PLAN COMMISSION AGENDA Wednesday, April 24, 2024 at 7:00 PM

To: Village of Mount Horeb Plan Commission
From: Village Planner: Ben Rohr, AICP
Date: April 24, 2024
Re: Proposed Zoning Map Amendment from R-3 Multi-Family Residential Zoning to a Planned Development - General Development Plan (GDP) for 11 Townhome Units at 107 Valley Drive, 111 Valley Drive, and 300 Adams Street for Rick North.

To: Village of Mount Horeb Plan Commission
From: Village Planner Ben Rohr, AICP
Date: April 24, 2024
Re: **UPDATED** Proposed Zoning Map Amendment from Planned Development with underlying Planned Business (PB) zoning to a modified Planned Development - General Development Plan (GDP) for a 3-Story Mixed-Use Building at 1881 Springdale Street for MMI, LLC.

SITE PLAN
PRINTED SCALE 1"=10'-0" 24x36 PAPER

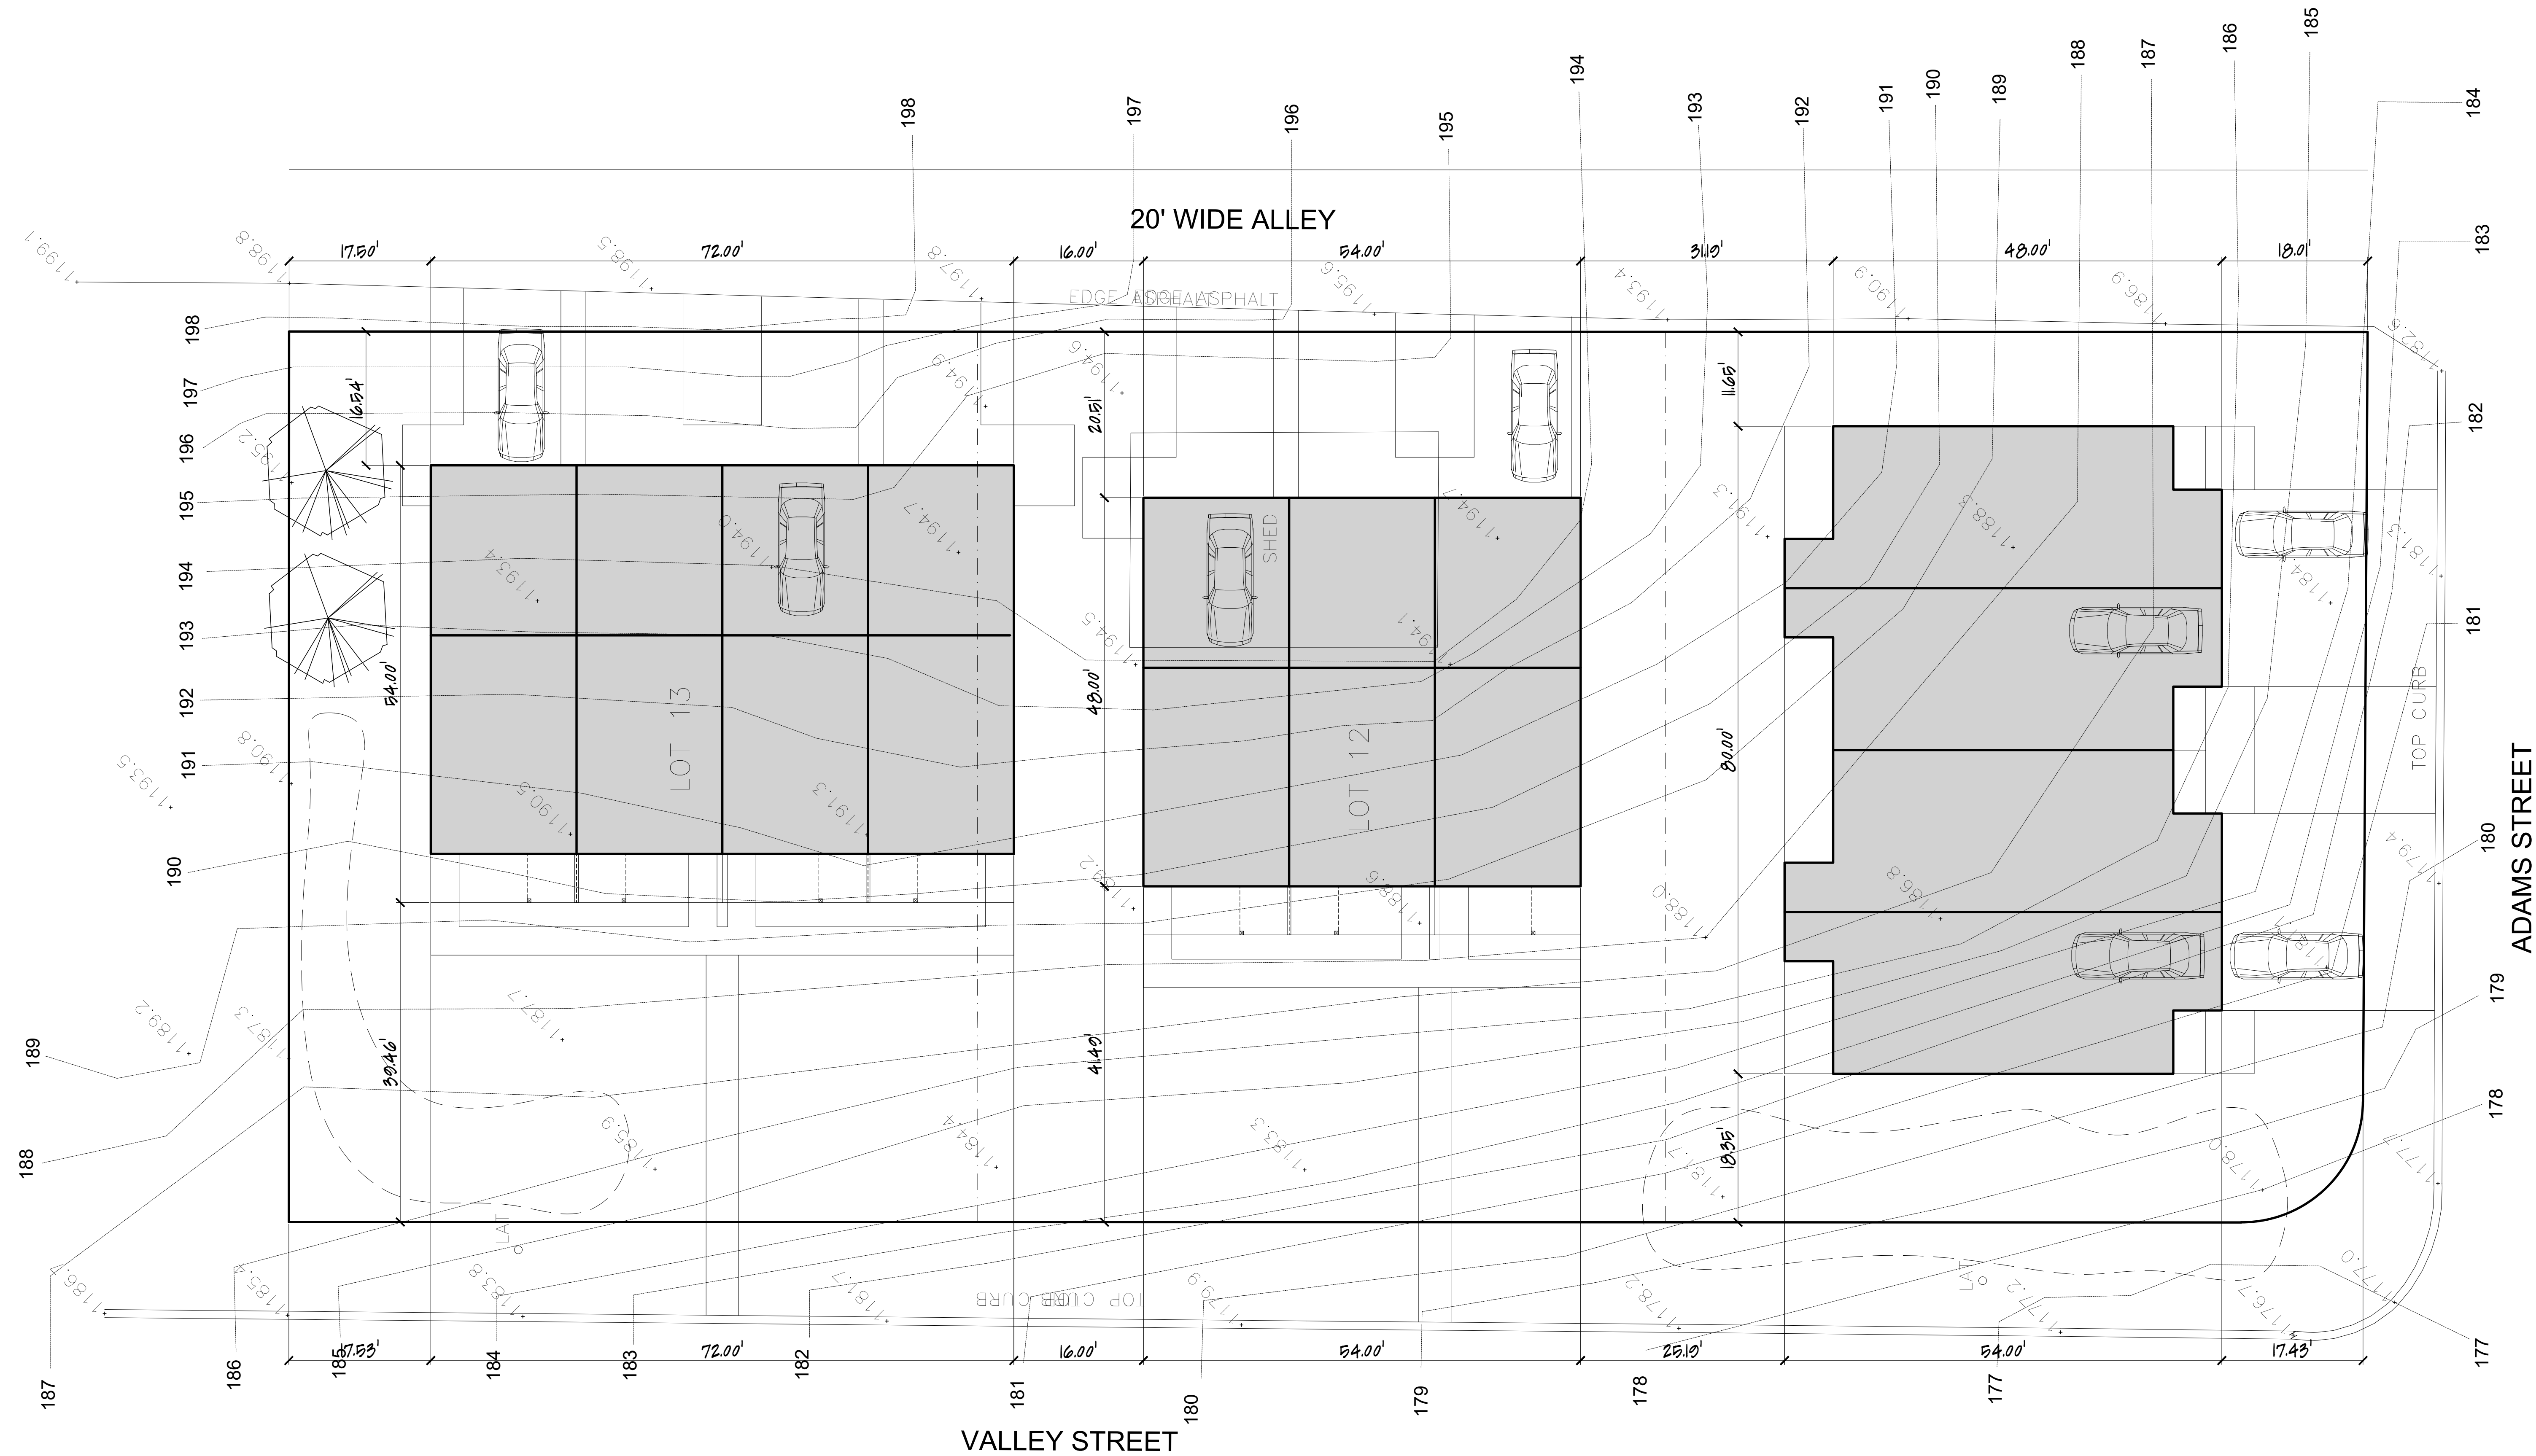
2. **Project Layout:** The project layout works well within the confines of the existing development patterns surrounding it. Access to all units will come from the alley or Adams Street, stormwater management on-site is improved, and the two different building orientations provide variety on the site and adequate building separation. There are no sidewalks in this area around this project site, but pedestrian connections are proposed between the buildings and Valley Drive.

4. **Architecture:** The proposed GDP as depicted on the elevations has a pitched roof which fits well in the context of the existing homes in the area. Overall, variation in materials, heights, projections from the façade, glazing, and roof pitch provide articulation along each façade.

5. **Site Design:** The proposed GDP as depicted on the site plan provides access to each unit from the alley and Adams Street and on-site parking within garages and driveways. The applicant has worked within the confines of the existing site topography to provide access from the alley and integrate ground floor walk-outs to those units facing Valley Drive.

6. **Landscaping:** The proposed GDP does not currently include a landscaping plan, but the specific plan for the site will be submitted and reviewed as part of the SIP process.

7. **Lighting:** The proposed GDP does not currently include a lighting plan, but the specific plan for the site will be submitted and reviewed as part of the SIP process.

8. **Signage:** The proposed GDP does not include any exterior signage. The specific signage plan for the site will be submitted and reviewed as part of the SIP process, if any is desired.

9. **Requested Zoning Flexibility:** I support granting flexibility for setbacks and bulk dimensional standard requirements because of the following. First, the Zoning Ordinance standards are clearly outdated and do not reflect the Village's goals, objectives, and priorities as outlined within the 2022 Comprehensive Plan. Second, the project helps meet the housing shortage experienced across Mount Horeb and increases the diversity of the Village's housing stock. Finally, the existing site configuration and surrounding built environment are leveraged to improve the development through walk-out lower levels, access off the alley and Adams Street, and plantings utilized as a buffer between existing lower-density development to the north. Overall, the proposed development provides a unique and high-quality infill residential development within Mount Horeb.

If acceptable to the Plan Commission, the Village Planner recommends the Plan Commission make, consider, and adopt a motion which makes a finding that the criteria for GDP submittals and approval have been met, and that also recommends approval of the proposed GDP Zoning Map Amendment by the Village Board, inclusive of full and continuous compliance with the submittal documents, the list of flexibilities and conditions provided in the submittal, and with any conditions identified by Village Staff and the Plan Commission, including 1-9, below:

1881 Springdale Street,
Mount Horeb, WI
SHEET TITLE
Site Plan

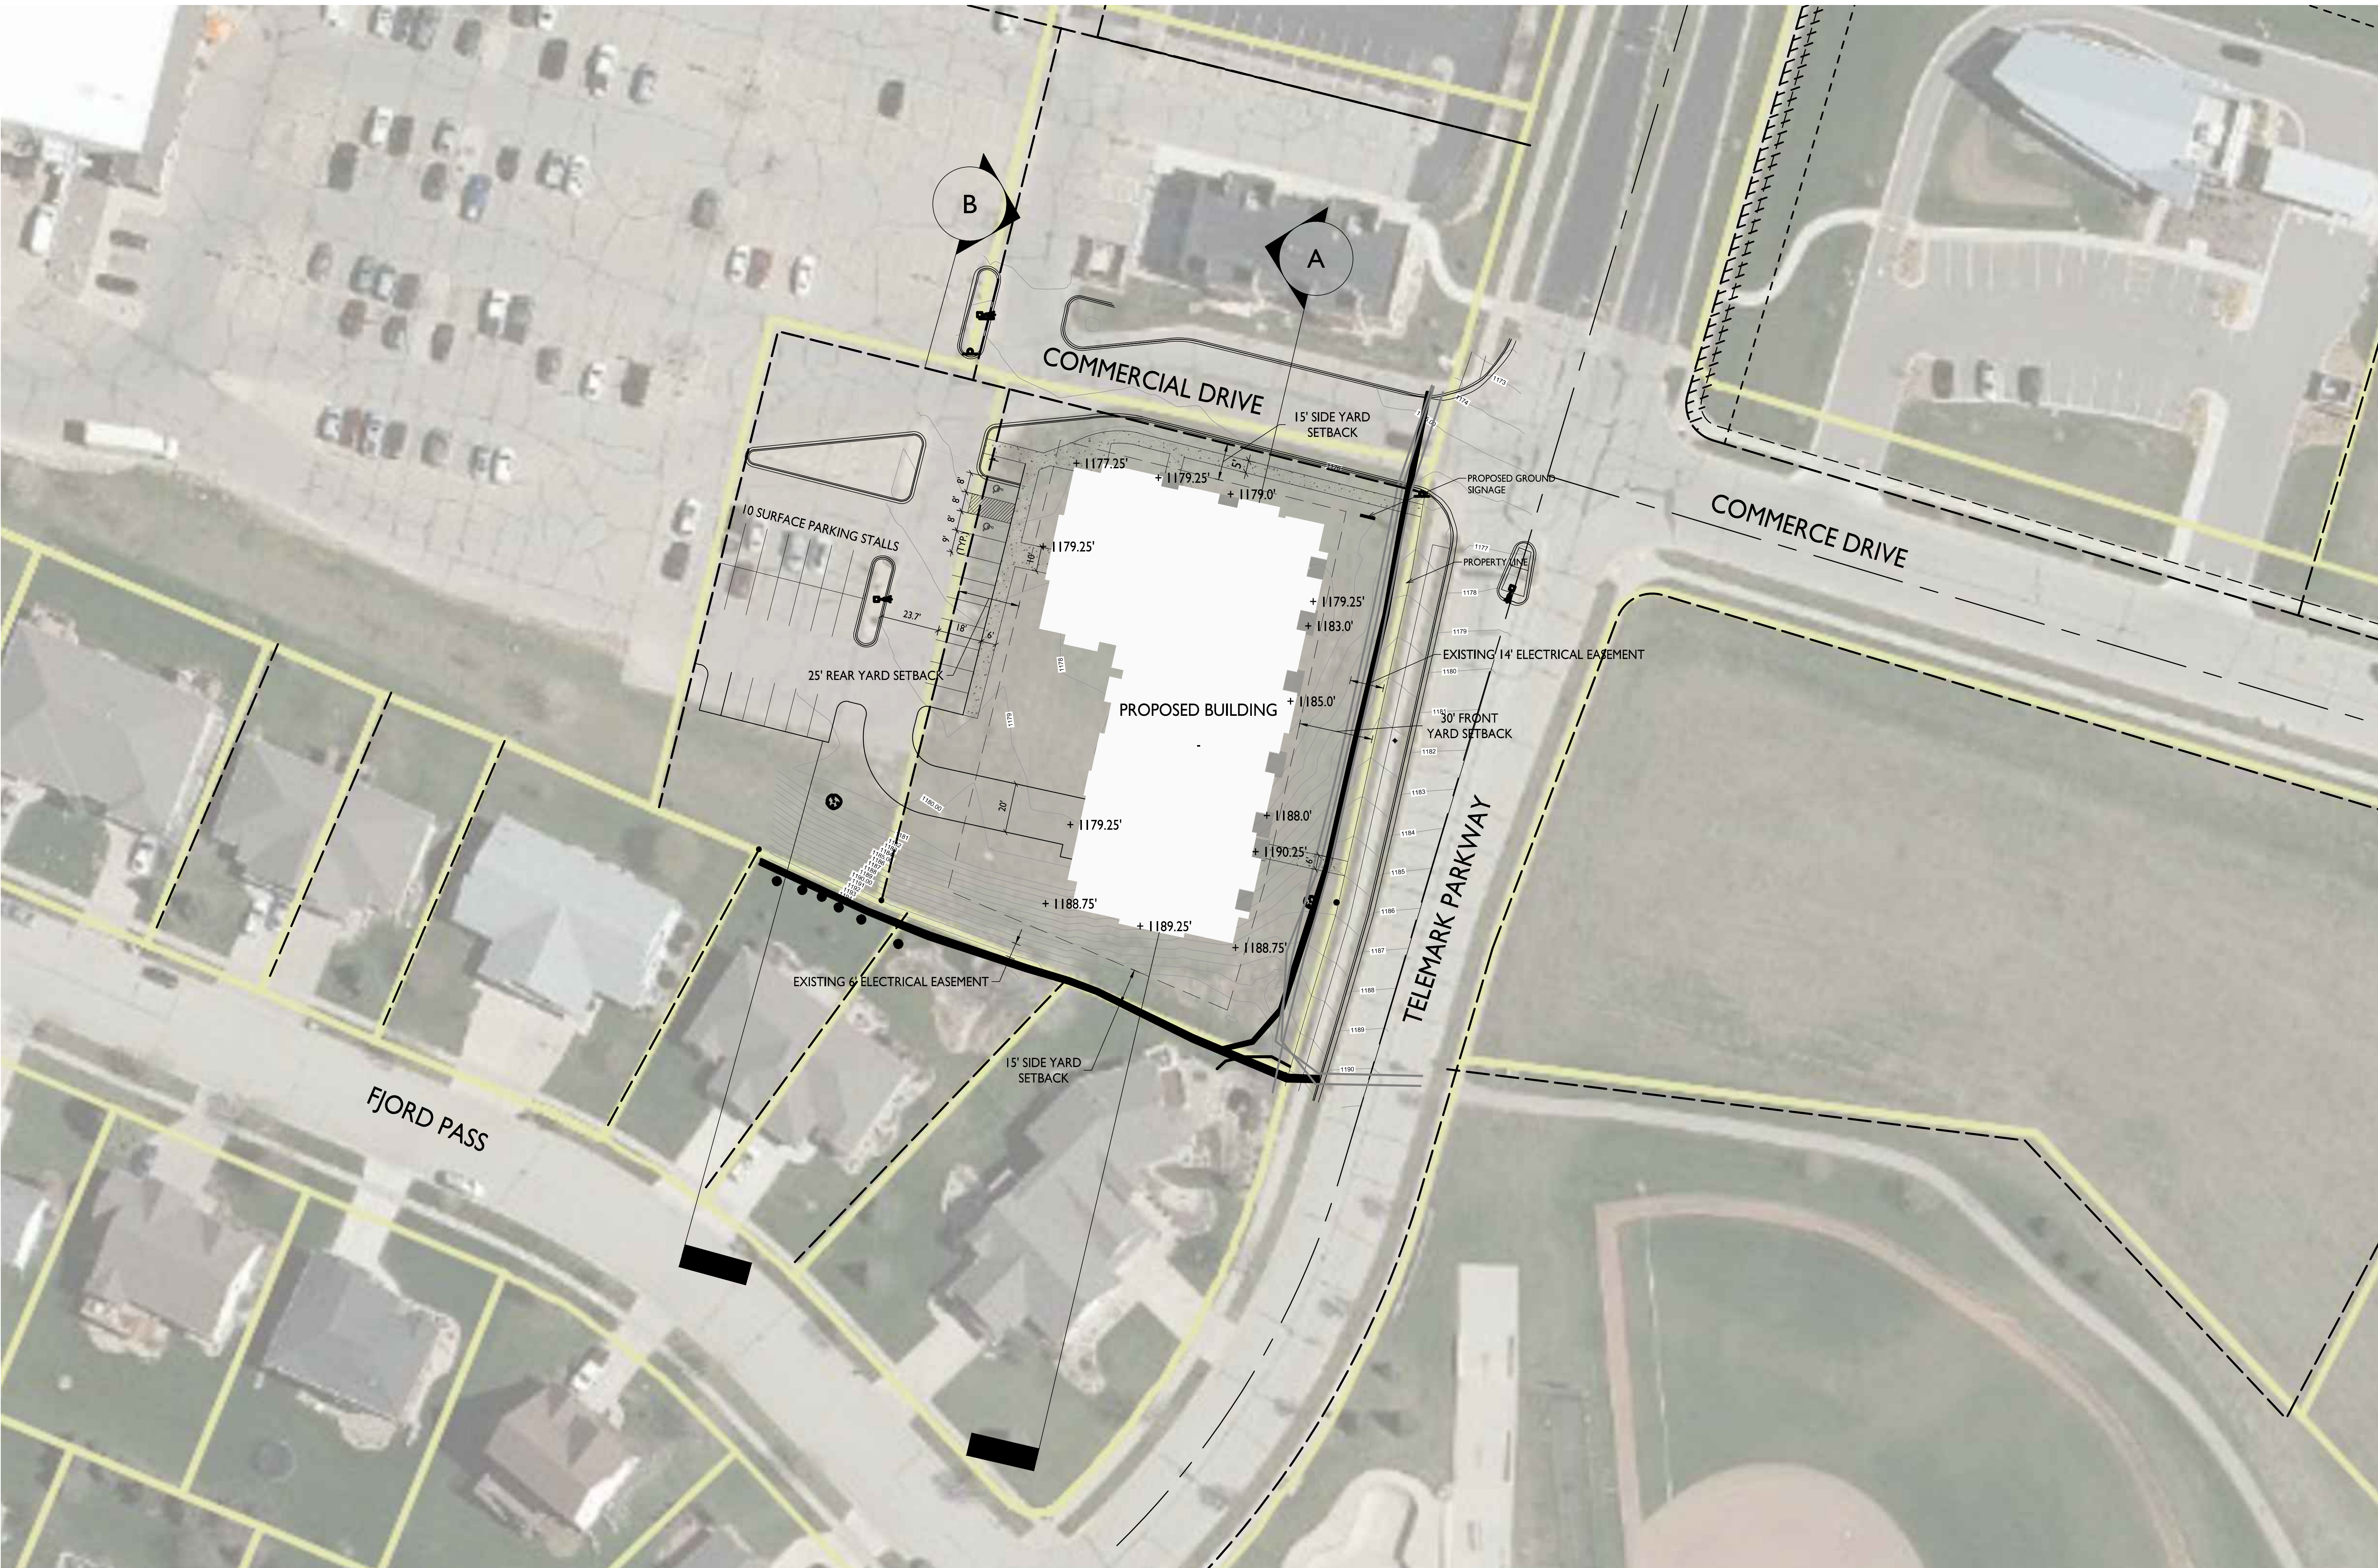
4. **Architecture:** The proposed GDP as depicted on the elevations has a pitched roof which fits well in the context of the existing homes to the south and several of the commercial developments fronting Springdale Street. The outlier in this area will be the Miller and Sons Supermarket that has a flat roof. Overall, variation in materials, heights, projections from the façade, glazing, and roof pitch provide articulation along each façade.

5. **Site Design:** The proposed GDP as depicted on the site plan provides vehicle, pedestrian, and bicycle access to the project and parking for all modes. It also includes both indoor and outdoor recreational amenities for residents and visitors. Due to anticipated increases in traffic volume using the commercial drive entry to the site from Telemark, the Village will explore additional pedestrian crossing improvements at the intersection.

6. **Landscaping:** The proposed GDP provides preliminary landscaping plans as depicted on the elevations and site plan. Parking lot, property line, and building foundation landscaping look to meet Village standards and will provide screening to the existing homes to the south. The specific plan for the site will be submitted and reviewed as part of the SIP process.

7. **Lighting:** The proposed GDP does not include an exterior lighting plan. The specific lighting plan for the site will be submitted and reviewed as part of the SIP process.

8. **Signage:** The GDP proposes a ground-mounted sign at the northeast corner of the site and on-building wall signs for the commercial tenant. The specific signage plan for the site will be submitted and reviewed as part of the SIP process.

9. **Requested Zoning Flexibility:** I support granting flexibility for the use, density, and intensity requirements because of the following. First, the Zoning Ordinance standards are clearly outdated and do not reflect the Village's goals, objectives, and priorities as outlined within the 2022 Comprehensive Plan. Second, the project helps meet the housing shortage currently in the Village and increases the diversity of the Village's housing stock. Finally, the existing site configuration and surrounding built environment are leveraged to improve the development through shielding the in-building parking via grade changes, accommodating new stormwater management on-site, and utilizing shared parking in an area currently

If acceptable to the Plan Commission, the Village Planner recommends the Plan Commission make, consider, and adopt a motion which makes a finding that the criteria for GDP submittals and approval have been met, and that also recommends approval of the proposed GDP Zoning Map Amendment by the Village Board, inclusive of full and continuous compliance with the submittal documents, the list of flexibilities and conditions provided in the submittal, and with any conditions identified by Village Staff and the Plan Commission, including 1-9, below:
